# WISSMAN TRACT

## 323.91 ACRE TRACT
## MASTER DEVELOPMENT PLAN

Re: Wissman 323.91 Acre Tract Subdivision MDP # 777A

The City Staff Development Review Committee has reviewed Wissman 323.91 Acre Tract Subdivision Master Development Plan M.D.P. # 777A. Please find enclosed a signed copy for your files. Your plan was accepted, however please note the following:

JOB NO. 5293-00
DATE SEPTEMBER 2004
DESIGNER AKP
CHECKED SLW DRAWN AKP
SHEET C1.00

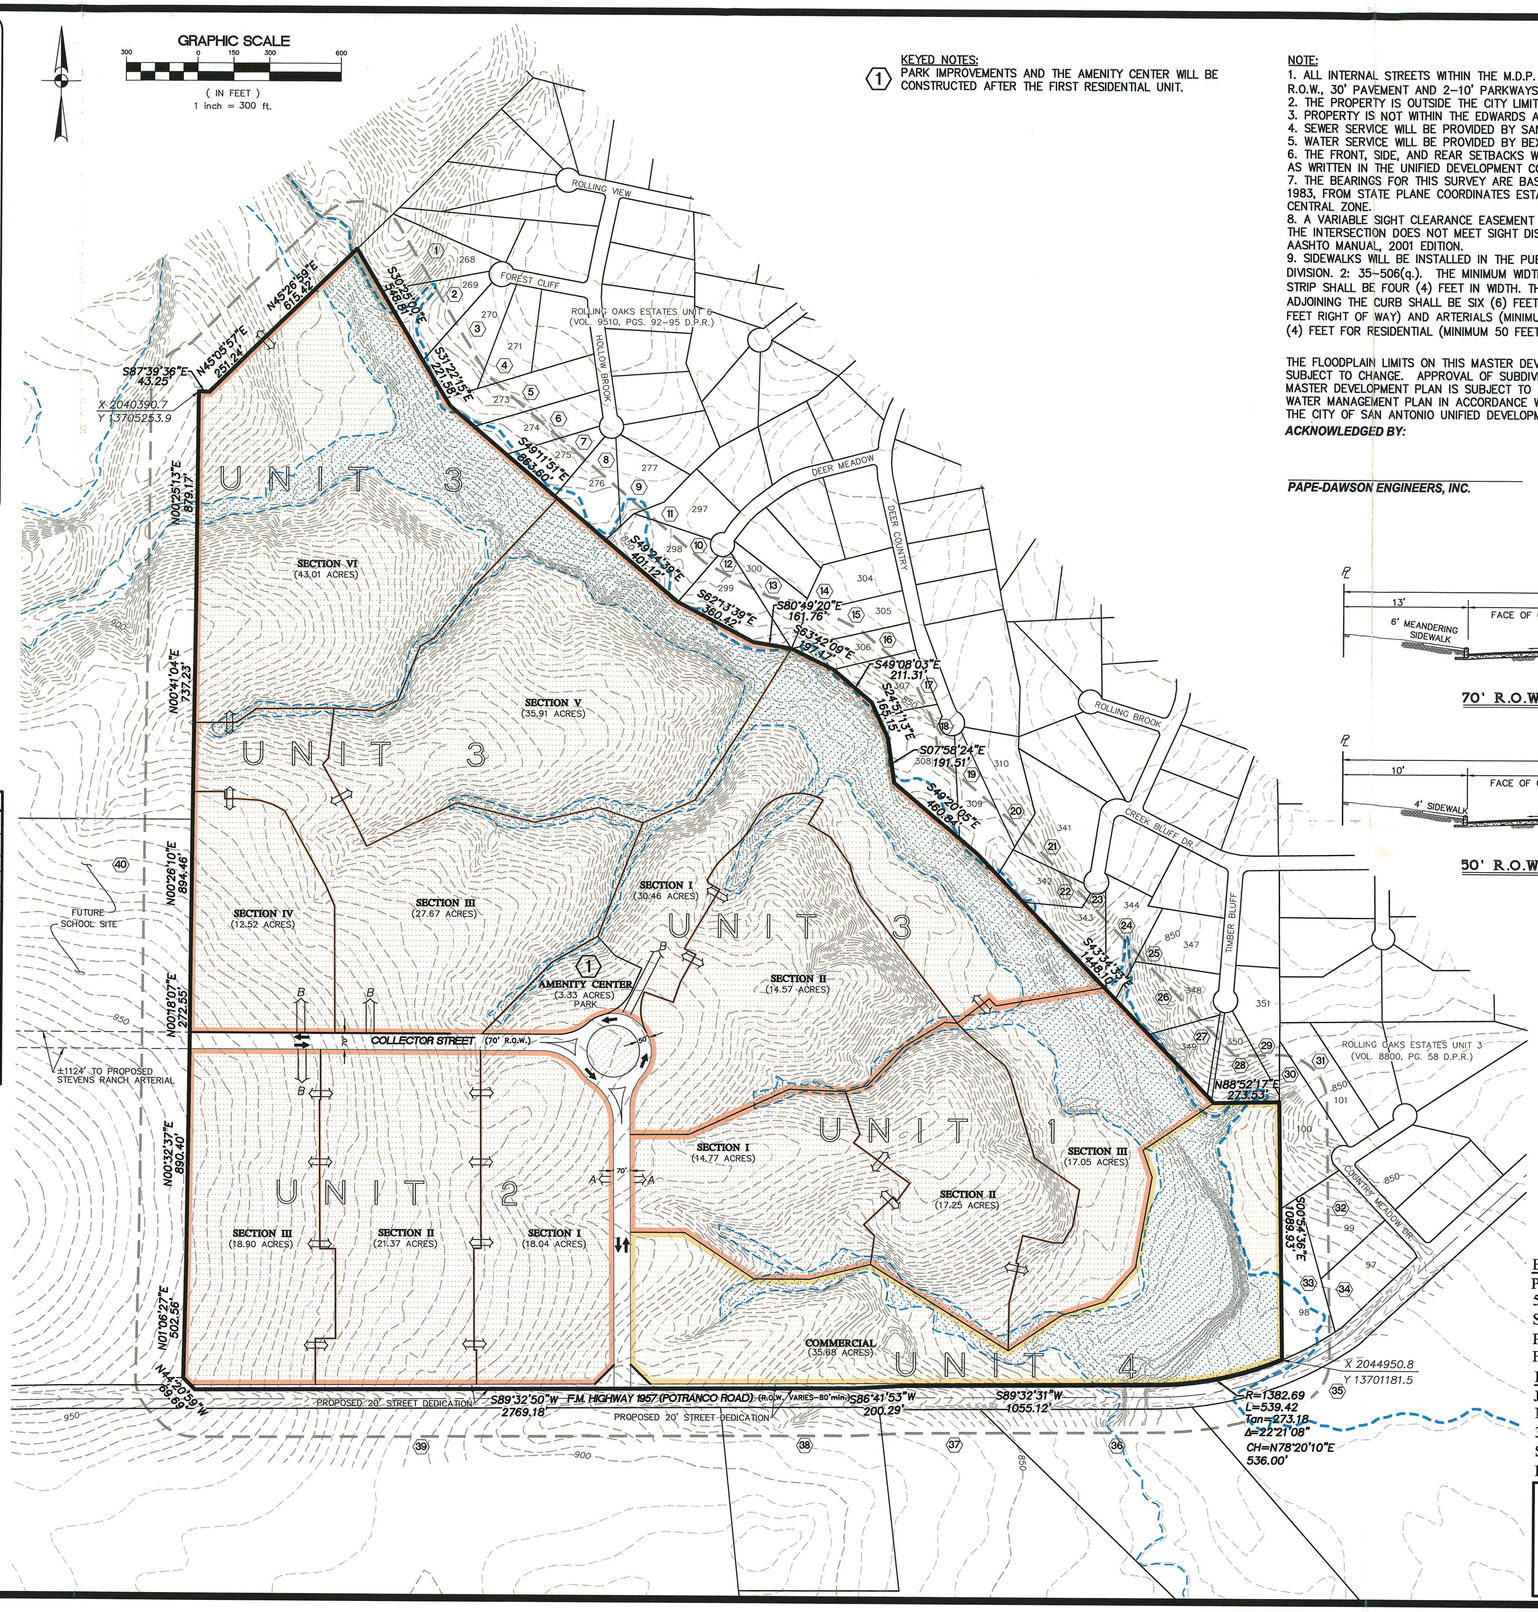
- In consideration of public safety and convenience, excessive grades by reason of topography should be avoided in street layouts and arrangements.

- The acceptance of this Master Development Plan # 777A is confined to the boundary limits of the site. Any projection(s) of future roadways outside the boundaries does not infer any set alignment of future roadways. All major arterials and streets shall follow all regulations.

- It will be expected that you will plat all of the property depicted in your Master Development Plan (M.D.P.) to include floodplains, drainage areas and open space.

1. A 7.57-acre Park is proposed to include a playground, trails, and picnic areas. Additionally, the applicant states that additional improvements will be included to earn credit against the park dedication requirement. A recreation center and swimming pool is proposed for a total of 4.0 acres of credit. The recreation center must be a minimum of 1,000 square feet and the swimming pool must have a minimum of 2,500 square feet of water surface area.

3. The construction of the park may be deferred to after the first residential unit, but must be completed prior to the platting of subsequent units.

2. County reserves the right to address driveways, street design, sight distance, ADA requirements, drainage and floodplain issues at time of platting.

4. Roadway configurations adjacent to and within this development shall be consistent with the recommendations set forth in the Stevens Ranch Traffic Impact Analysis dated November 2003.
